BID ADDENDUM NO. 4

OWNER: EDGEMONT SCHOOL DISTRICT

PROJECT NAME: HIGH SCHOOL RESOURCE & BUILDING E RENOVATIONS
& ATHLETIC FIELD RECONSTRUCTION

DATE: April 14, 2026

Chain Link Fence - Galvanized - 6' Height
SCALE: NTS

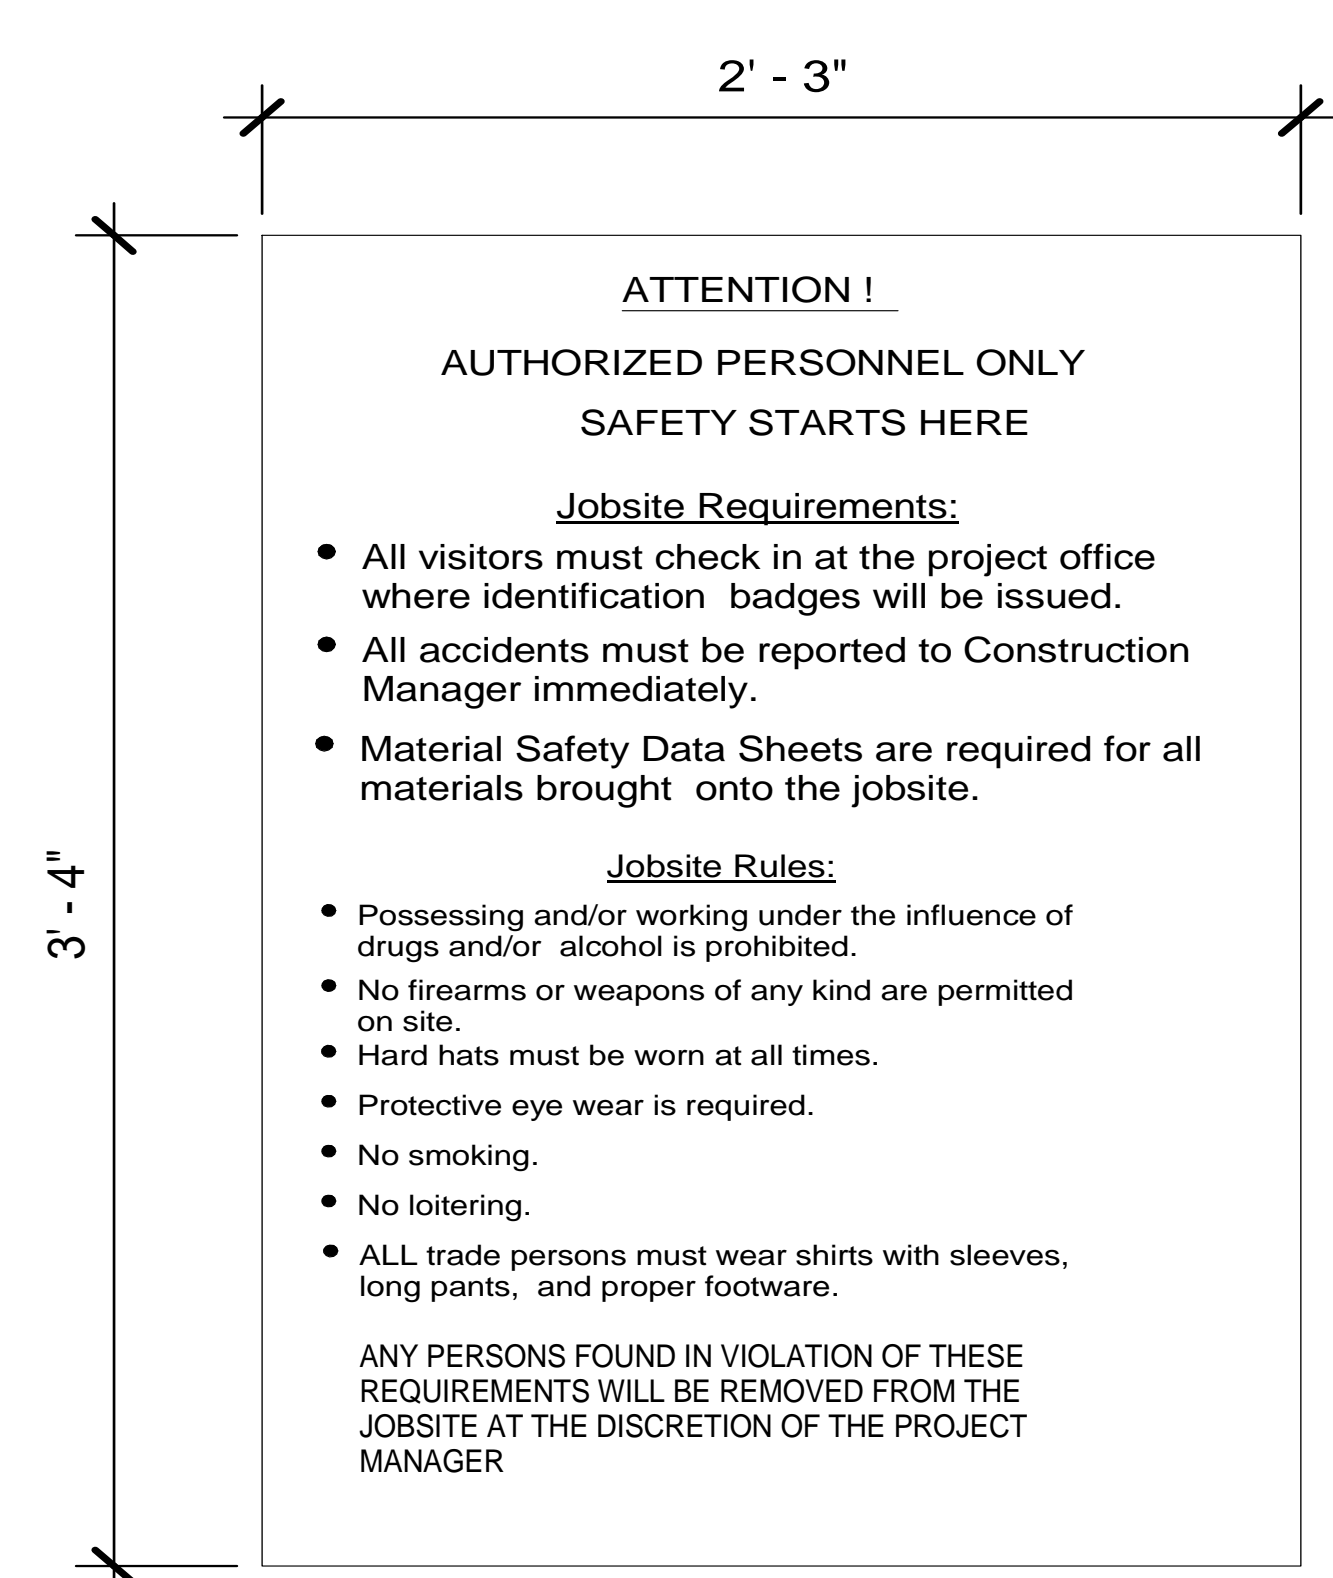
- ALL CHAINLINK FENCING AND GATING SHALL BE COVERED WITH 500 (BS/FT) 175GSM WINDSCREEN WITH 90% SHADE PERCENTAGE, AND NFPA 701 TEST METHOD II RATED.

1 LAYDOWN, STAGING AND ACCESS PLAN (RESOURCE BUILDING AND BUILDING 'E')
 SCALE: N.T.S.

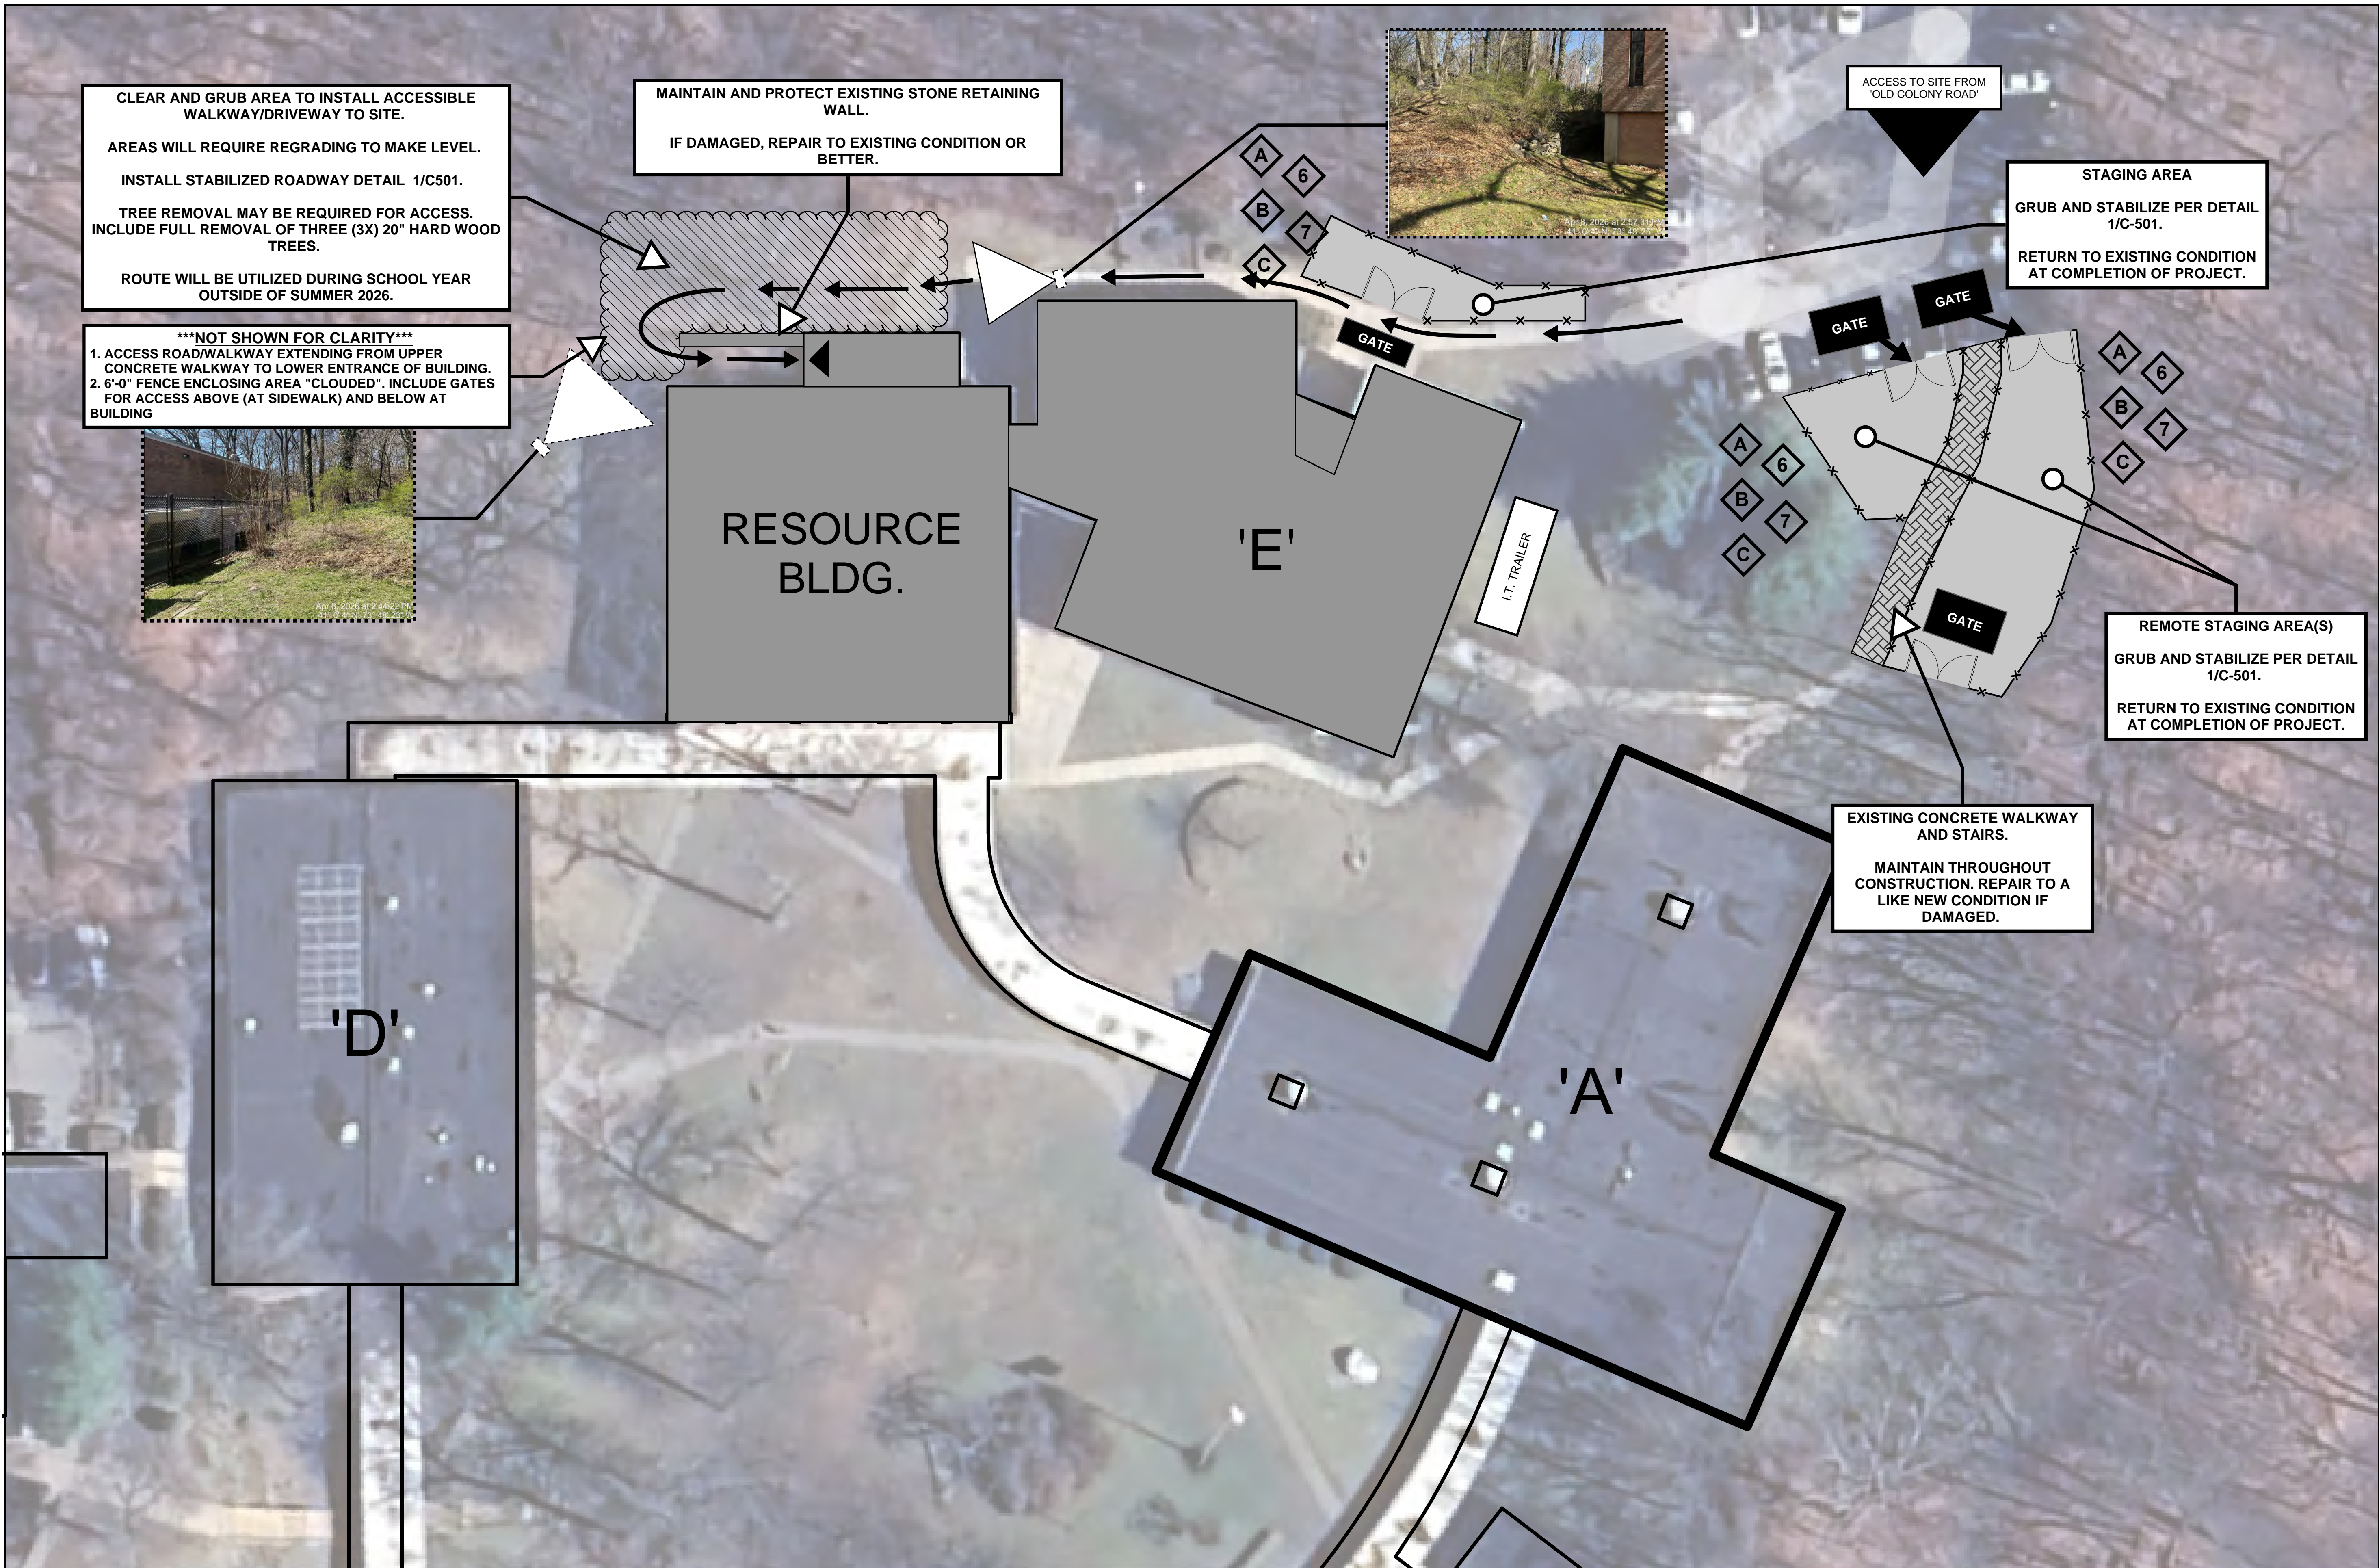
- 6'-0" CONSTRUCTION CHAIN-LINK FENCE WITH PRIVACY SCREENING
- 20'-0" SWINGING CHAIN-LINK VEHICLE GATE. GATE SHALL BE LOCKED BY GENERAL CONSTRUCTION TRADE AT END OF EACH BUSINESS DAY, AND REMAIN CLOSED DURING CONSTRUCTION.
- OWNER DAILY ACCESS/ ROUTING AROUND SITE. APPROVAL NEEDED FOR CONSTRUCTION ACCESS

1 TEMPORARY CONSTRUCTION PLAN (INTERIOR - FIRST FLOOR)
 SCALE: N.T.S.

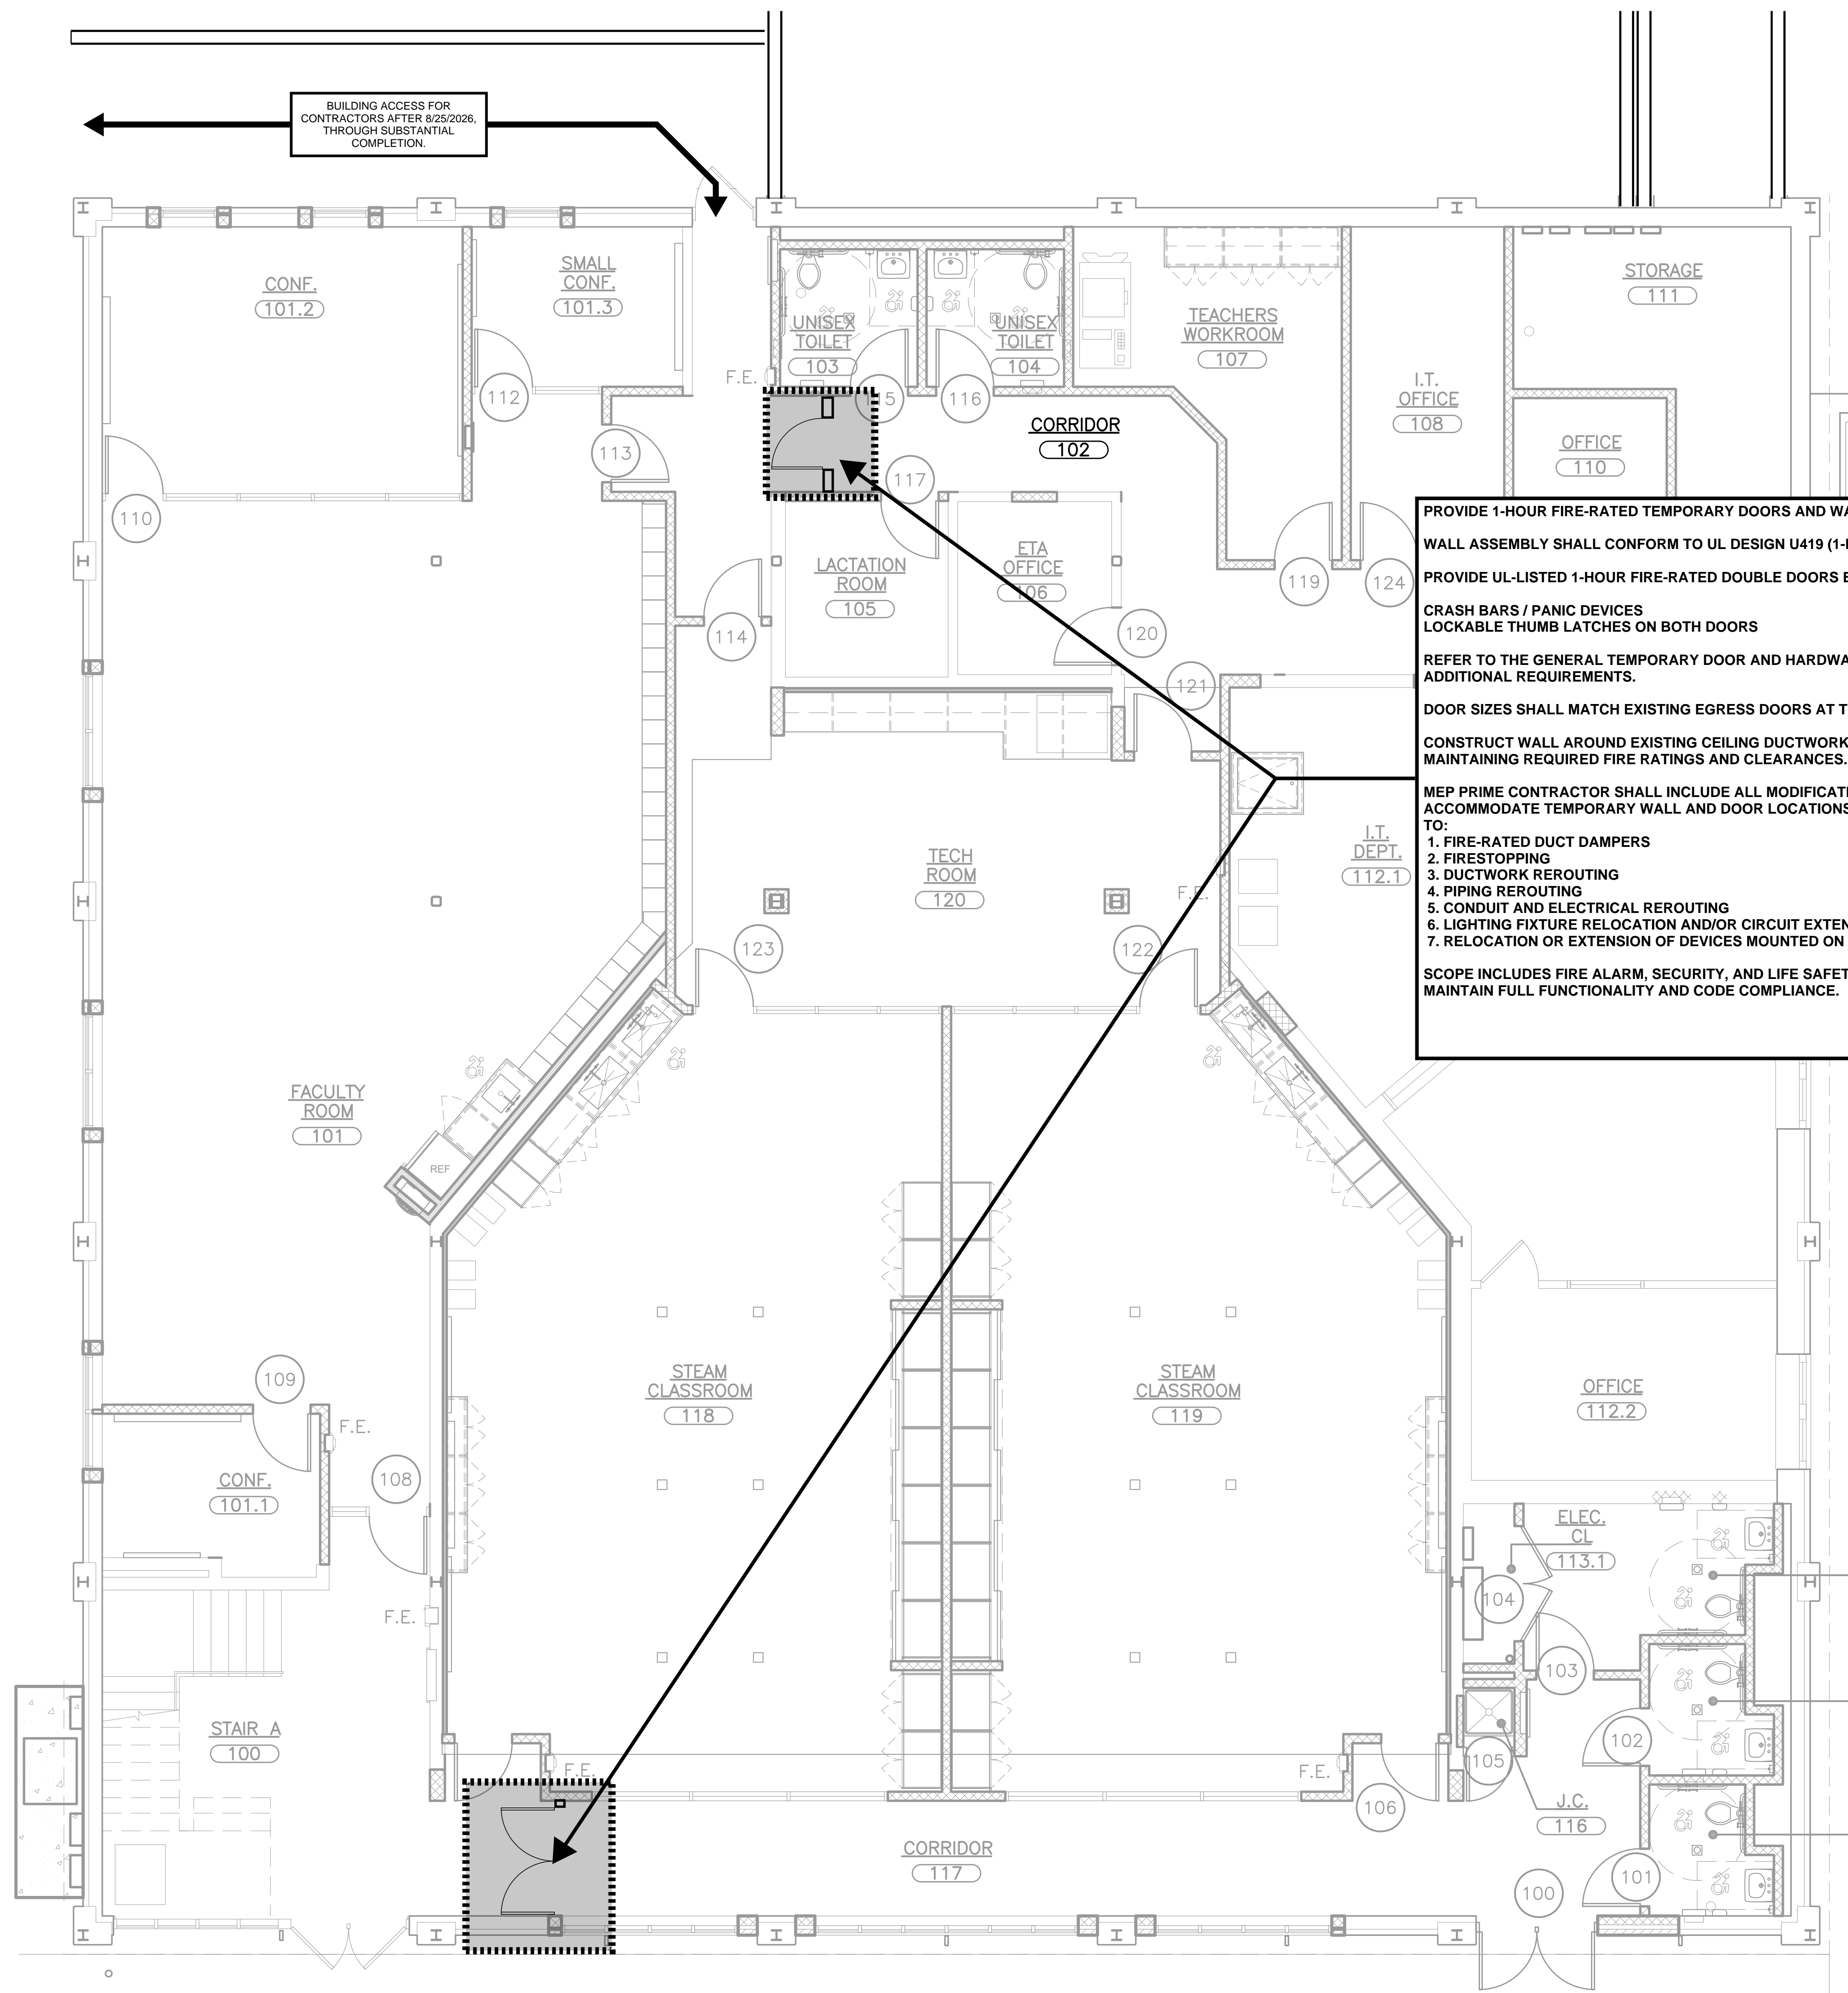
PROVIDE 1-HOUR FIRE-RATED TEMPORARY DOORS AND WALL ASSEMBLY.
 WALL ASSEMBLY SHALL CONFORM TO UL DESIGN U419 (1-HOUR FIRE-RESISTANCE RATING).
 PROVIDE UL-LISTED 1-HOUR FIRE-RATED DOUBLE DOORS EQUIPPED WITH:
 CRASH BARS / PANIC DEVICES
 LOCKABLE THUMB LATCHES ON BOTH DOORS

DOOR SIZES SHALL MATCH EXISTING EGRESS DOORS AT THE VESTIBULE.

CONSTRUCT WALL AROUND EXISTING CEILING DUCTWORK, CONDUIT, AND PIPING, MAINTAINING REQUIRED FIRE RATINGS AND CLEARANCES.

MEP PRIME CONTRACTOR SHALL INCLUDE ALL MODIFICATIONS REQUIRED TO ACCOMMODATE TEMPORARY WALL AND DOOR LOCATIONS, INCLUDING BUT NOT LIMITED TO:

SCOPE INCLUDES FIRE ALARM, SECURITY, AND LIFE SAFETY SYSTEMS, AS REQUIRED TO MAINTAIN FULL FUNCTIONALITY AND CODE COMPLIANCE.
